# Waterfront – Main Corridor North of Union St

## Meeting Summary

**September 18, 2014****2:30 – 5:00 pm****Type**CIP Project  
Waterfront Core Project**Phase**

Schematic Design

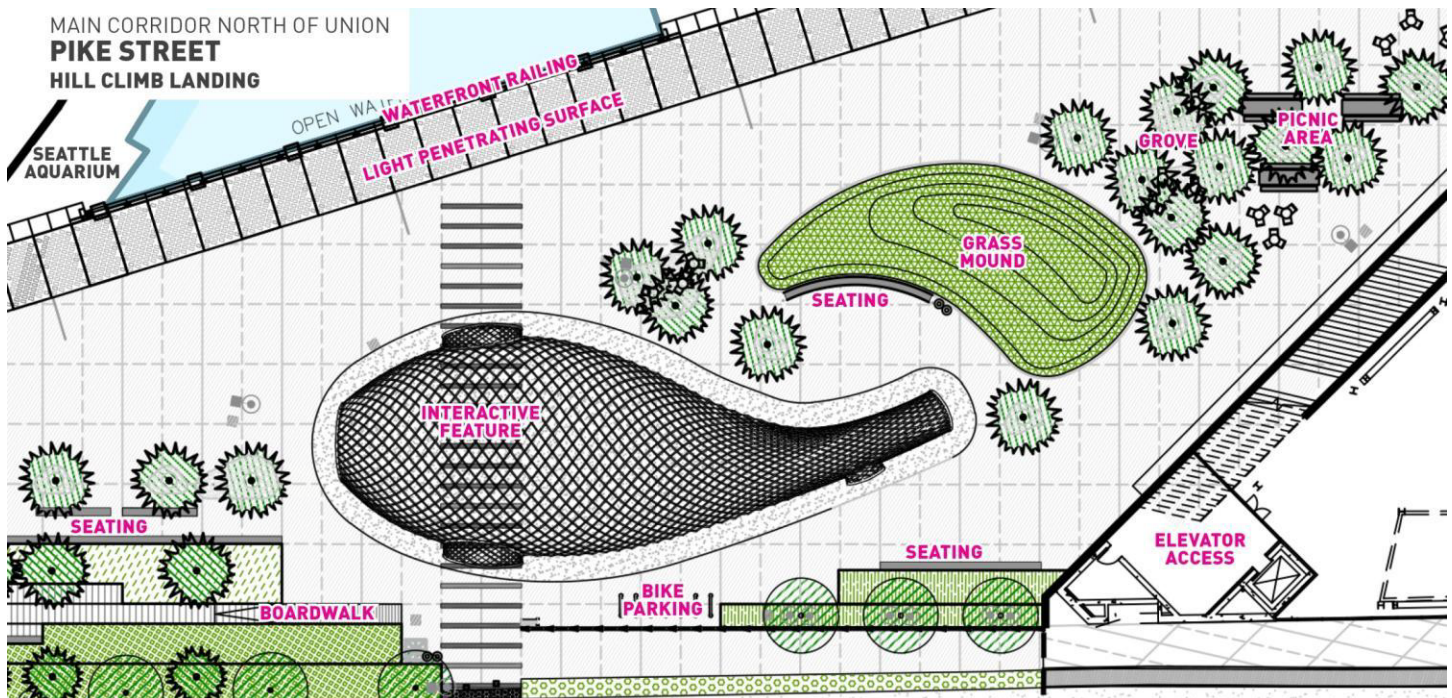
3. Explore additional opportunities to integrate salvaged material into the design as you have with the promenade handrails.
4. Study the number and placement of objects in Aquarium Plaza (below). Give more space around them rather than crowding this zone. Consider transitioning these objects into one another as you have successfully with paving treatments.

5. There is some uncertainty among the Commission about the fish sculpture (right) and a desire to understand its form and design in more detail. Do not let the fish sculpture preclude the opportunity for art to be fully integrated into the design for Pier 62/63 and the Central Public Open Space.

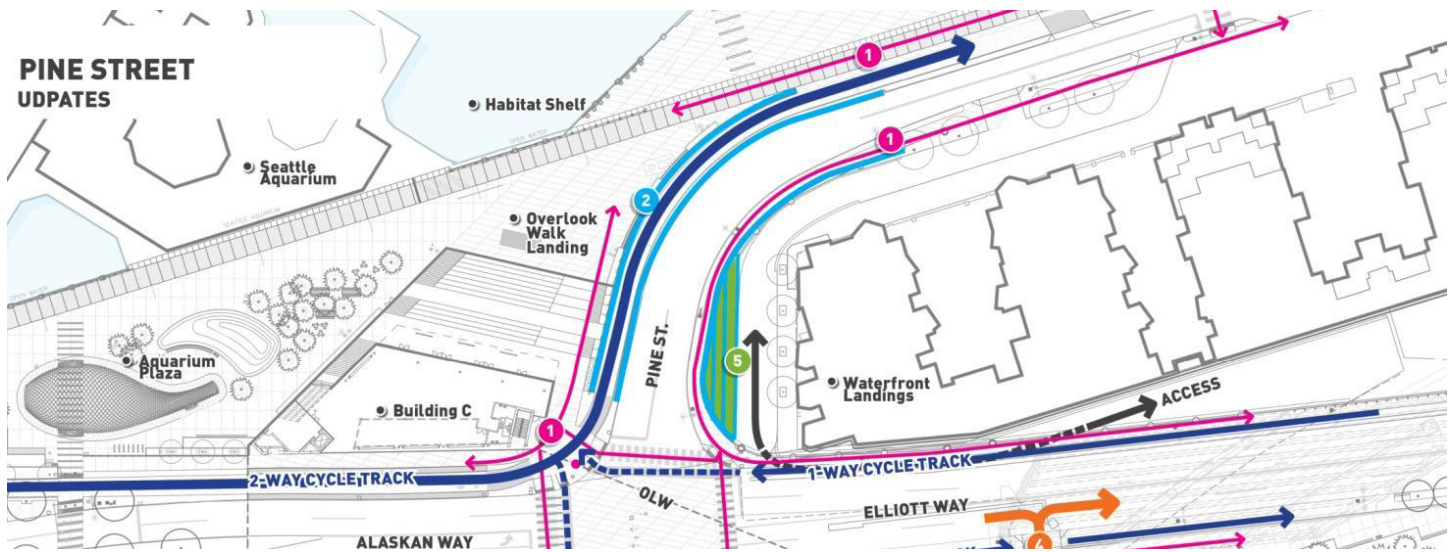
8. On Pine St, show more detail about how the cycle track and retaining walls transition at Alaskan Way near the light penetrating surface functionally, materially, and formally (below). The separation of cars and bicycles on Pine St feels strong and improved in section and elevation. The Commission appreciates that the project team has considered Waterfront Landings in the proposed design.

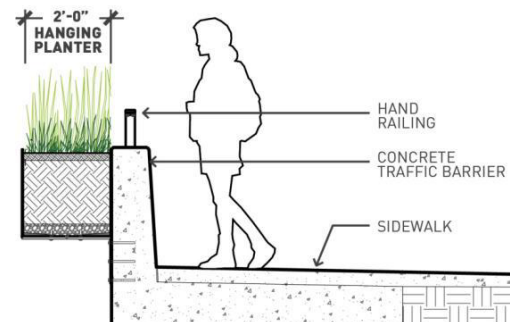
9. The one-way cycle tracks on Elliott Way are an improvement over the previous configuration. Take care when detailing important elements like the planter boxes along the edge of Elliott Way (below right) so they do not become marginalized or prone to collecting trash.
10. Be diligent in choosing, evaluating, and prototyping materials and coatings for durability and effect.
11. While the Commission recognizes the uncertainty about the future of the Lenora Street Bridge, the existing plantings are valuable given their scale and should be retained if at all possible.
12. Continue to develop direct, usable connections at Blanchard St, which has improved significantly from concept design (below). The potential development parcel could be an opportunity to serve latent community needs and might be less valuable as open space given the nearby portal site at Battery St.
